Neopixel Control PCB R3

PG 4/7/2021

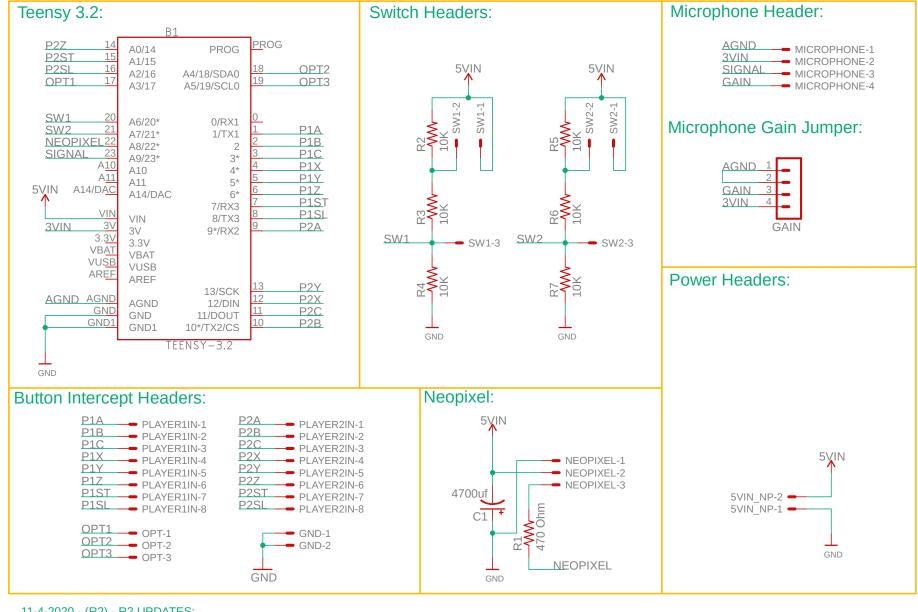
11-4-2020 - (R2) - R2 UPDATES:

- 1. MOVED ALL CONTROLS UP ONE PIN ON TEENSY (D0 WOULD NOT REGISTER A ON P1)
- 2. REMOVED OPT4 AS IT IS NOT USED IN THE DESIGN
- 3. SWAPPED 2X 11 PIN MOLEX HEADERS FOR 2X 8 PIN (P1 AND P2), 1X 3 PIN (OPT) AND 1X 2 PIN (GND) TO BETTER SPLIT THE GROUPS OF INPUTS
- 4. REMOVED THE 3 PIN 5VIN MOLEX CONNECTOR AND CONSOLIDATED 5VIN TO AN 2 PIN CONNECTOR (FORMERLY 5VINNP)

4-7-2021 - (R3) - R3 UPDATES:

1. CHANGED R2-R7 TO 10K (FORMERLY 1K)

NOTE: FIRMWARE WILL NEED TO BE REVISED FOR R3 PCB TO WORK AS ALL INPUTS HAVE BEEN REASSIGNED

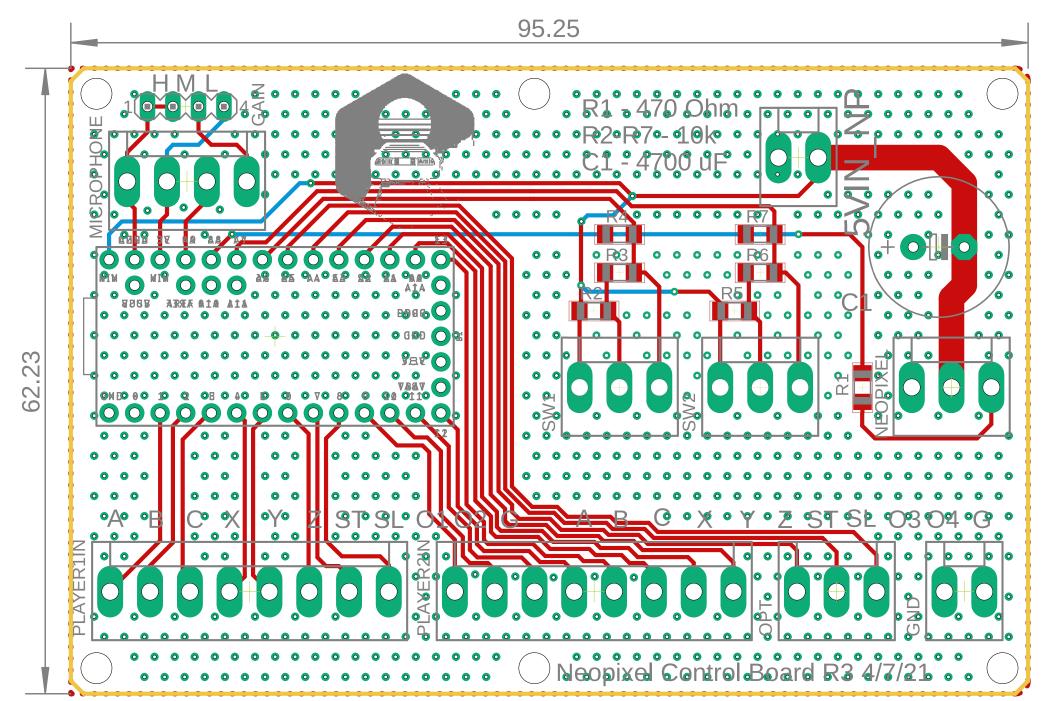
11-4-2020 - (R2) - R2 UPDATES:

- 1. MOVED ALL CONTROLS UP ONE PIN ON TEENSY (D0 WOULD NOT REGISTER A ON P1).
- 2. REMOVED OPT4 AS IT IS NOT USED IN THE DESIGN
- 3. SWAPPED 2X 11 PIN MOLEX HEADERS FOR 2X 8 PIN (P1 AND P2), 1X 3 PIN (OPT) AND 1X 2 PIN (GND) TO BETTER SPLIT THE GROUPS OF INPUTS
- 4. REMOVED THE 3 PIN 5VIN MOLEX CONNECTOR AND CONSOLIDATED 5VIN TO AN 2 PIN CONNECTOR (FORMERLY 5VINNP)
- 5. ALL INPUT TRACES RERUN, STICHING RERUN TO MATCH NEW TRACES

4-7-2021 - (R3) - R3 UPDATES:

- 1. CHANGED R2-R7 TO 10K (FORMERLY 1K)
- 2. ADDED COMPONENT VALUES TO PCB

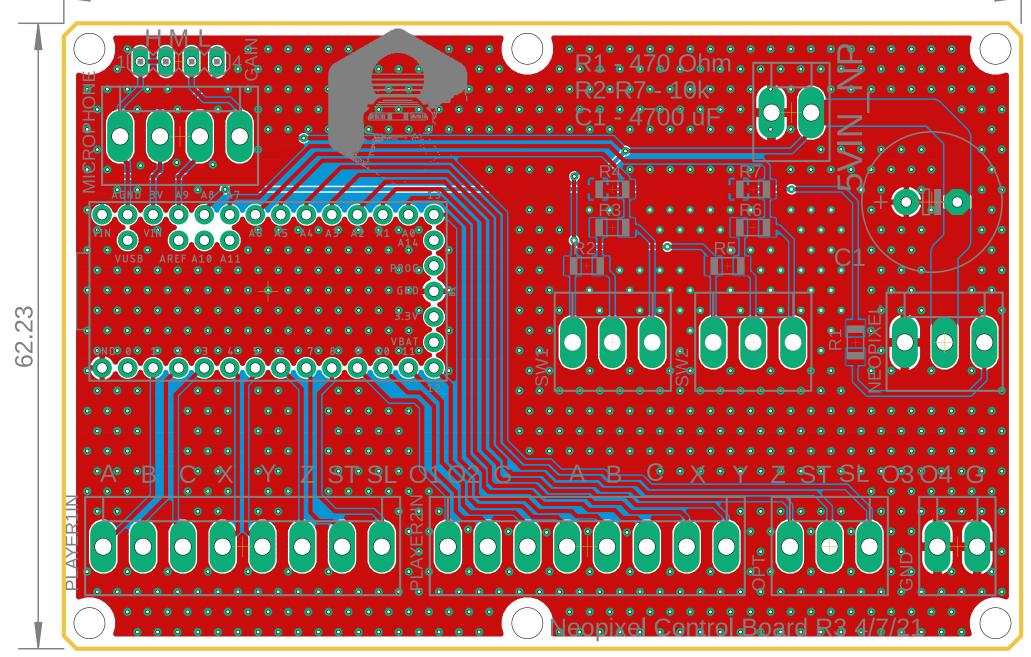
11-4-2020 - (R2) - R2 UPDATES:

- 1. MOVED ALL CONTROLS UP ONE PIN ON TEENSY (D0 WOULD NOT REGISTER A ON P1).
- 2. REMOVED OPT4 AS IT IS NOT USED IN THE DESIGN
- 3. SWAPPED 2X 11 PIN MOLEX HEADERS FOR 2X 8 PIN (P1 AND P2), 1X 3 PIN (OPT) AND 1X 2 PIN (GND) TO BETTER SPLIT THE GROUPS OF INPUTS
- 4. REMOVED THE 3 PIN 5VIN MOLEX CONNECTOR AND CONSOLIDATED 5VIN TO AN 2 PIN CONNECTOR (FORMERLY 5VINNP)
- 5. ALL INPUT TRACES RERUN, STICHING RERUN TO MATCH NEW TRACES

4-7-2021 - (R3) - R3 UPDATES:

- 1. CHANGED R2-R7 TO 10K (FORMERLY 1K)
- 2. ADDED COMPONENT VALUES TO PCB
